Project	IEEE 802.16 Broadband Wireless Access Working Group < http://ieee802.org/16 >	
Title	Enhancement of association using SCAN-REQ/RSP	
Date Submitted	2004-05-07	
Source(s)	Sungjin Lee Yeongmoon Son Jungje Son Changhoi Koo Samsung Electronic, Suwon P.O.Box 105, 416, Maetan-3dong, Yeongtong1-gu, Suwon-i., Gyeonggi-do, Korea 442-742	Voice : +82-31-279-5091 Fax : +82-31-279-5130 steve.lee@samsung.com ym1004.son@samsung.com jungje.son@samsung.com chkoo@samsung.com
Re:	This contribution is response to call for contribution about IEEE802.16e-D2	
Abstract	This document proposes the scheme enhancing association operation with SCAN-REQ/RSP	
Purpose	Discuss and Adopt the advanced feature for periodic ranging in sleep mode in the IEEE802.16e group.	
Notice	This document has been prepared to assist IEEE 802.16. It is offered as a basis for discussion and is not binding on the contributing individual(s) or organization(s). The material in this document is subject to change in form and content after further study. The contributor(s) reserve(s) the right to add, amend or withdraw material contained herein.

Enhancement of Association using SCAN-REQ/RSP

Figure E.2—Example BS advertisement and scanning (with association) by MSS request

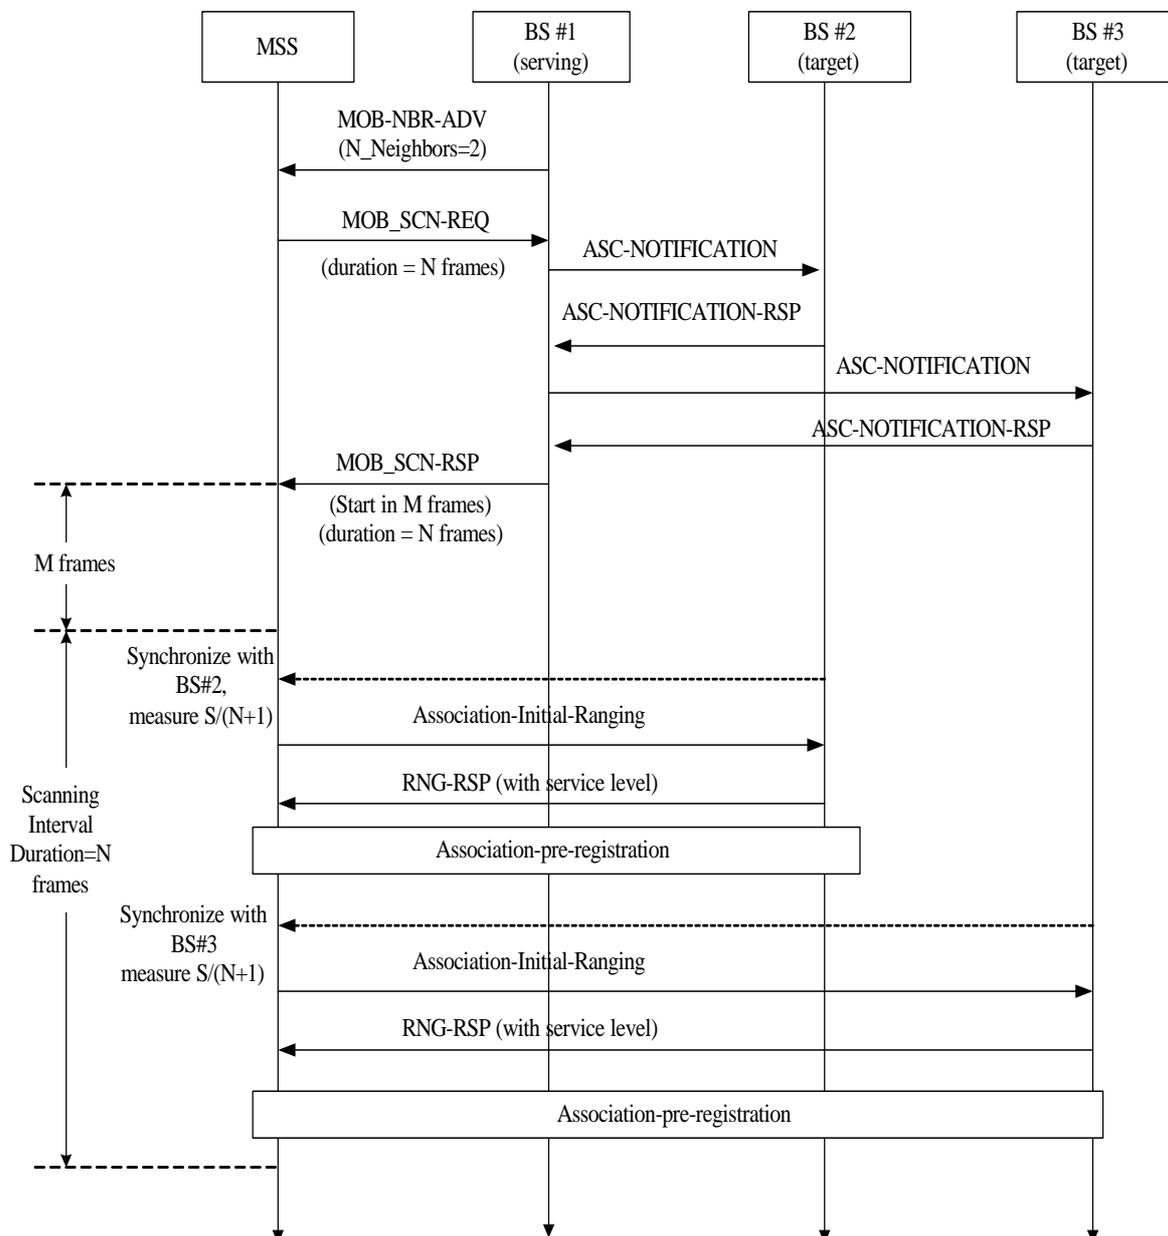
Therefore we propose fast access scheme for association operation in order to allow MSS fast access to target BS. A modified SCN-REQ and SCN-RSP message are proposed to enhance MSS operation of association for Scan Interval. SCN-Notification and SCN-Notification-RSP messages are also proposed to inform target BSs of the MSS information.

A MSS trying association can access to target BS with fast UL ranging IE same as handoff case with above proposed messages and scenario.
